ADDENDUM No. 1

LAKE AHQUABI STATE PARK  
CAMPGROUND UPGRADE PROJECT  
WARREN COUNTY, IOWA  
PROJECT NUMBER: 22-05-91-01

January 12, 2022

SANITARY SEWER PUMP STATION

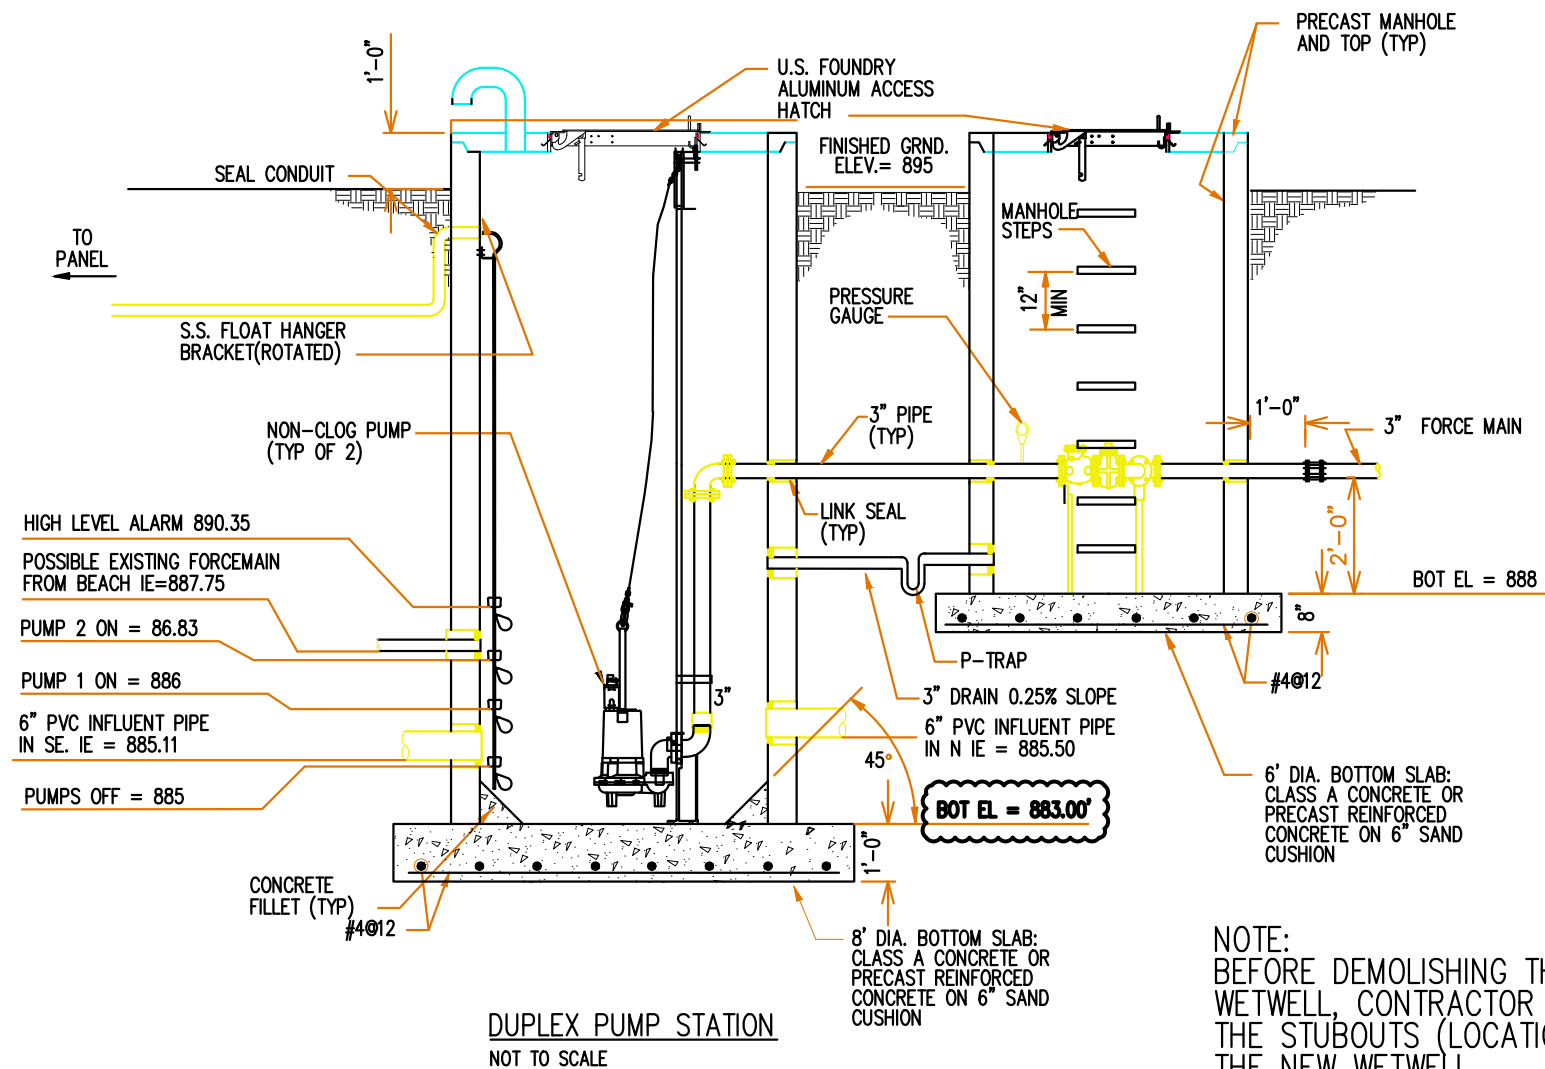
- A. Sheet #26, SANITARY SEWER PUMP STATION, The bottom elevation for the pump station should be 883.00'.
- B. Sheet #26, SANITARY SEWER PUMP STATION, Approved equal product for the submersible grinder pumps shall be the 'Pentair Myers Model VSX30-21-50 Explosion-Proof Submersible Grinder Pump'.
